Y1A, Y1B, Y1C- High-Voltage (HV) Battery Measurements during HV Battery Repair

Models	Model Year	Model Type	VIN Range	Vehicle-Specific Equipment
Taycan	All	Y1A, Y1B, Y1C	All	N/A

Revision History

Figure 1 - 28-module HV Battery measurement points

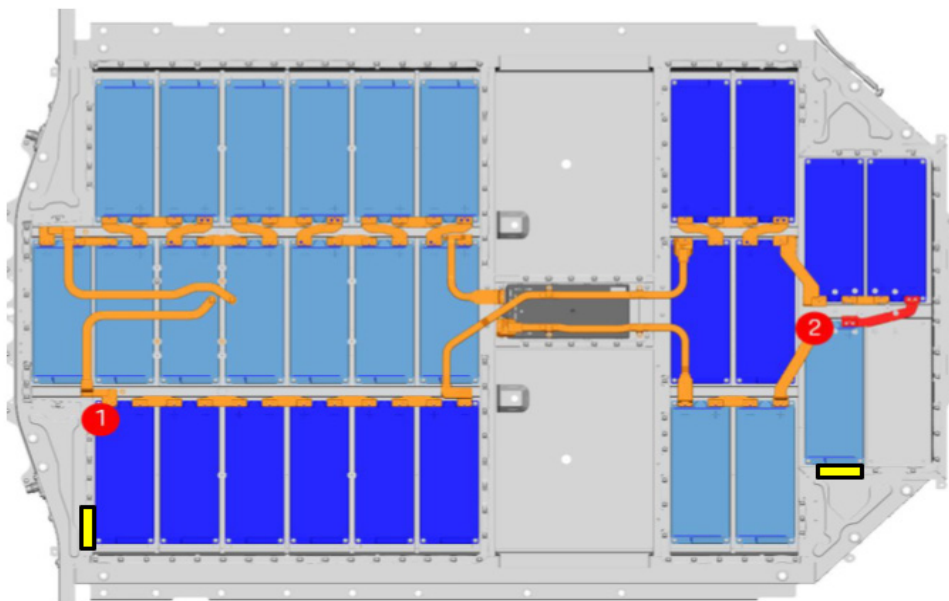
DST Procedure for 28-module Taycan Battery Pack (Figure 1)

- Only two DSTs are to be performed on a 28-module battery pack during repair.
- The busbar indicated in red must be removed prior to measurements at either point.

- Perform an IR test at points 1 and 2 before the DST at those points.
- Perform a DST only at points 1 and 2 shown below for each repair scope.
- The yellow boxes in *Figure 1* designate the sections of frame where a lid screw can be hand-started to ground the dielectric strength tester.

- Also perform IR tests at points 1 and 2 after a DST, with the negative probe in contact with a clean spot on the silver frame surface designated by the yellow boxes.

- If the final IR test at measurement point 1 fails, remove busbars and CMC connections from each module shaded in dark blue for further IR testing as described in the following *Updated IR Measurement Procedure* sections.

- If the final IR test at measurement point 2 fails, remove busbars and CMC connections from each module shaded in light blue module for further IR testing as described in the following *Updated IR Measurement Procedure* sections.

- EXAMPLE: Point 1 passes DST and point 2 fails.
 - Perform IR tests on each light blue module in the failing section (In this example, section 2). No additional work is required for the passing modules in section 1.

Figure 2 - 28-module Flowchart

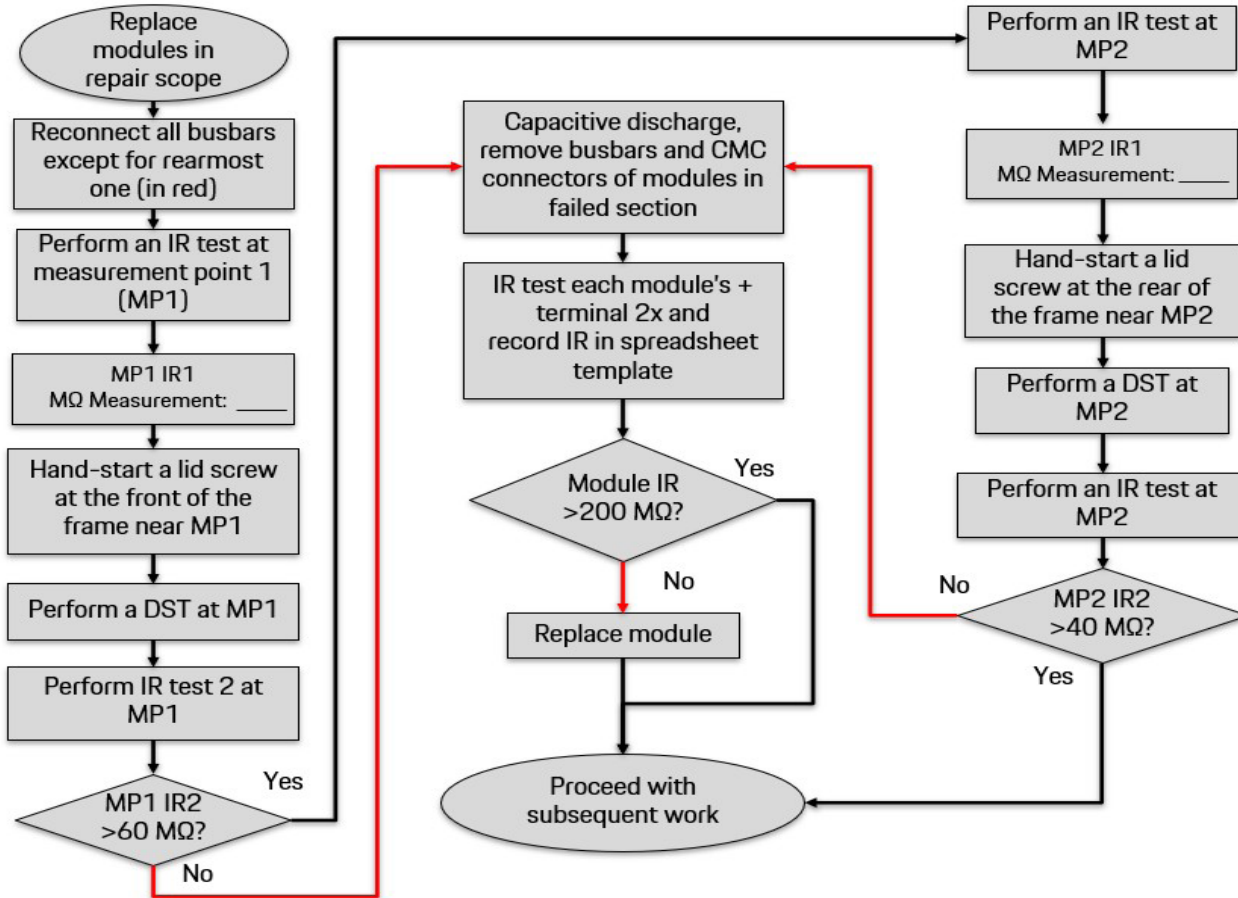
Flowcharts of this process for each battery variant are available in figures to follow. The end step "Proceed with subsequent work" can refer to the next measurement point or completion of the repair depending on scenario.

Figure 3 - 33-module HV Battery measurement points

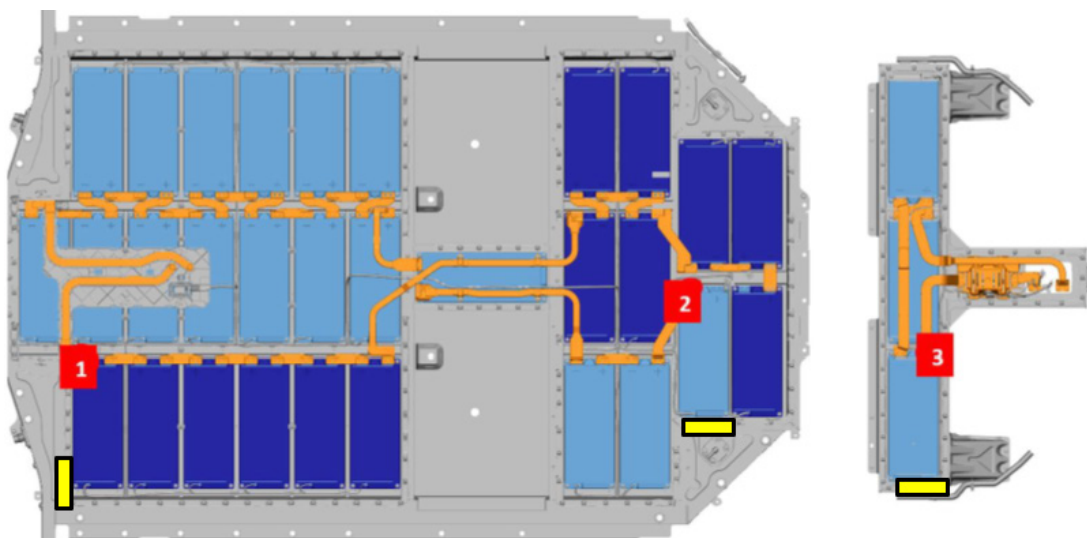
DST Procedure for 33-module Taycan Battery Pack (Figure 3)

- Only a total of three or four DST's are to be performed on the 33-module battery pack during repair, depending on scope.
 - ▷ Perform a DST only at points 1, 2, and 3 for any repair scope involving the lower-level modules.

- ▷ Repair scopes in only the upper "T" section require an initial DST (in addition to the points in *figure 2*) at the mid-pack fuse as shown in step 3.9.3 of Safety test after assembly work on the high-voltage battery with 33 modules in WM 270803A5. Only proceed with removing lower lid if this initial DST fails.

- If removed, the upper "T" Section should be placed aside on a VAS 6762/44 Insulating mat during testing.
- Perform an IR test at points 1, 2 and 3 before the DST at those points.

- The yellow boxes in *Figure 3* designate the section of frame where a lid screw can be hand-started to ground the dielectric strength tester. If performing a DST on the mid-pack fuse, use the location on the upper "T" section to ground the negative clamp.

- Perform IR tests at points 1, 2, and 3 after a DST, with the negative probe in contact with a clean spot on the silver frame surface designated by the yellow boxes.

- If the final IR test at measurement point 1 fails, remove busbars and CMC connections from each module shaded in dark blue for further IR testing as described in the following *Updated IR Measurement Procedure* sections.

- If the final IR test at measurement point 2 fails, remove busbars and CMC connections from each module shaded in light blue for further IR testing as described in the following *Updated IR Measurement Procedure* sections.

- If the final IR test at measurement point 3 fails, remove busbars and CMC connections from each module in the upper "T" section for further IR testing as described in the following *Updated IR Measurement Procedure* sections.

- EXAMPLE: It is possible for battery to have point 1 pass, point 2 pass, and point 3 fail the DST. It would then only be required to perform further IR tests on each module in the upper "T" section. No additional work would be required for the passing lower sections.

Figure 6 - IR Test at Positive Terminal

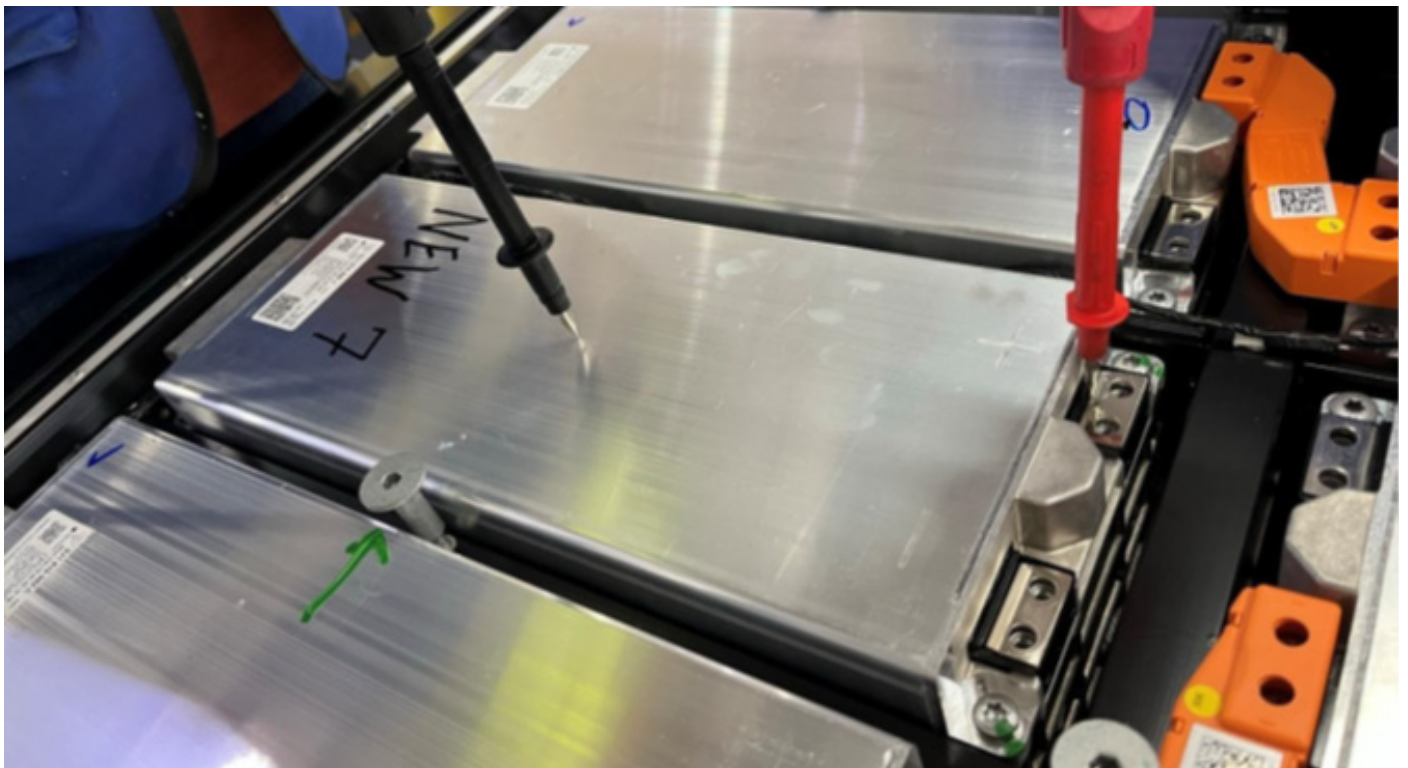
- When IR testing a module on the positive terminal: Contact the positive terminal with the red test probe as shown in *Figure 6*.

Module IR Testing Procedure: Positive Terminal (Figure 6)

- Place the red probe at the edge closest to the black plastic surrounding the terminal to avoid scratching the conductive surface.
 - CAUTION: pay attention to the angle of the red probe in this case. Avoid contact with the side of the probe and the edge of the module housing. Use a plastic probe cap to expose only the tip of the probe if available.
- Maintain contact with the black probe to the module case in the center. Ensure that the module casing surface is clean at the point of contact.
- The equipotential bonding cable is not suitable as a ground point during this test. Use both straight probes directly on the module to isolate conductive influences.

Figure 7 - Insulation resistance measurement in PIWIS Tester

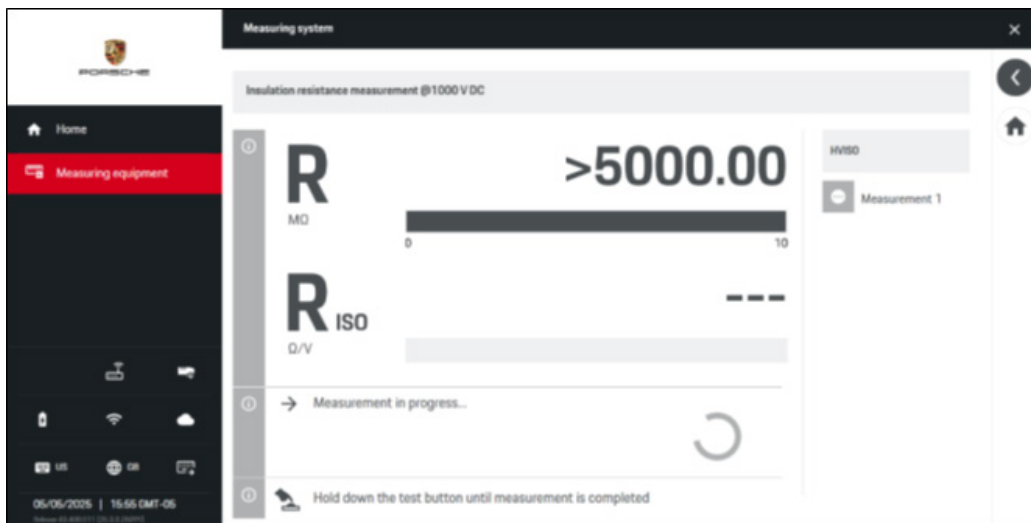
IR Testing Pass/Fail Criteria (Figure 7)

- Shown below is an example of passing test result of >5000 MΩ. This is the reading displayed when IR measures above the 500 MΩ measuring threshold.
- IR values between 200 MΩ and 500 MΩ are also acceptable for the second measurement on a terminal.
- If the first IR test on either module terminal fails, but the second one passes, the module is okay and should not be replaced.
- If any second terminal IR test shows a number below 200 MΩ, this is considered a failure.
- If IR is below the measurement threshold, the IR test won't complete in the measurement equipment display. If the IR test fails to produce a value after multiple attempts on any module terminal, replace it.
- Document any failures in the "Module insulation Resistance Template" Excel file attachment and attach to the repair PCSS entry.
